REMARKS

To make the present invention novel with respect to the citations, the applicant decide to cancel Claims 1 to 7, without prejudice or disclaimer of the subject matter thereof, and add new claims 8 to 14. The added new claim 8 is based on the original claim 1 and the features of Fig. 3 of the present invention. The new claim 9, 10, 11, 12, 13 and 14 add features same as the original claim 2, 3, 4, 5, 6, and 7, respectively, to the new claims 8. Thereby, it is assured that the new claims are based on the original claim and specification and thus no new matter is added. The relation of the new claims with respect to the original claims are shown in the following.

FIG. 1

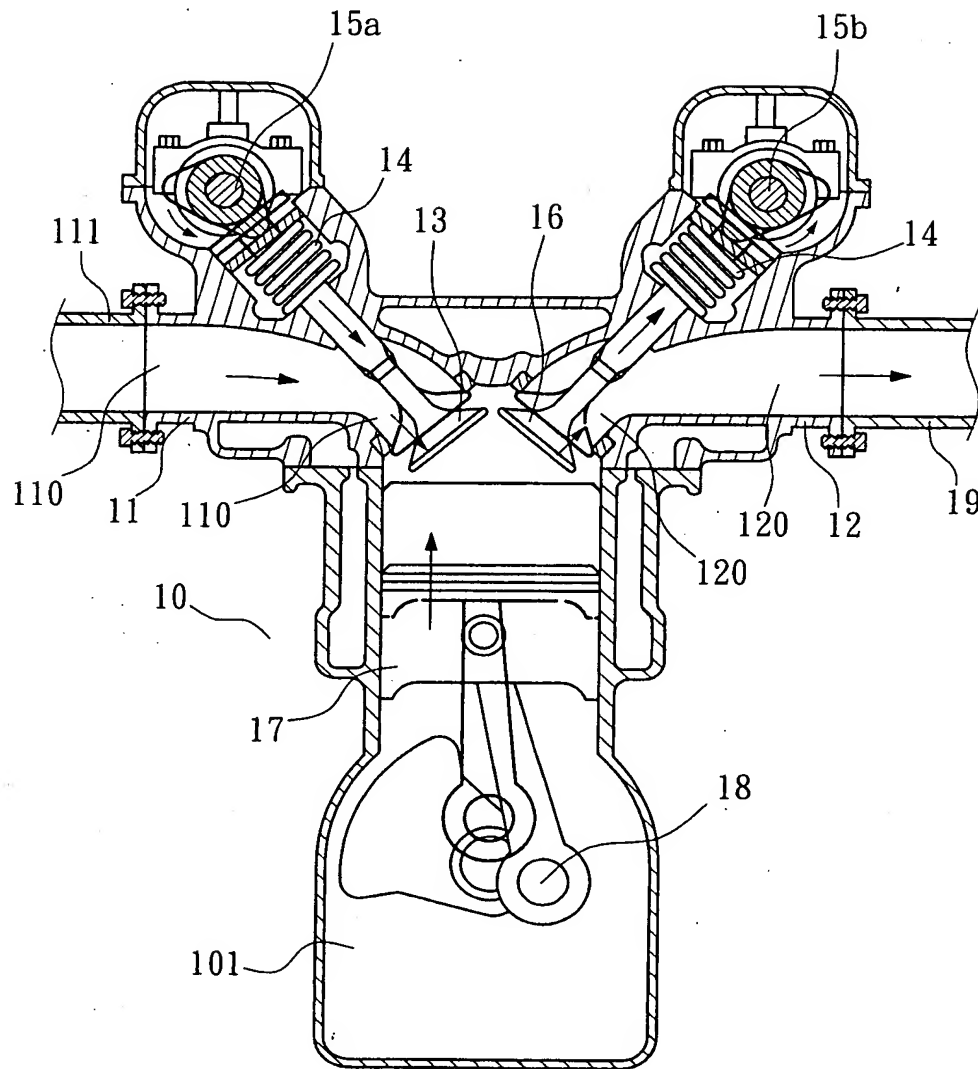
Please amend the Fig. 1 as the attached amended copy. In the amendment of the figure, the figure is added with "Prior Art". No other portion is amended. Thereby, no new matter is added.
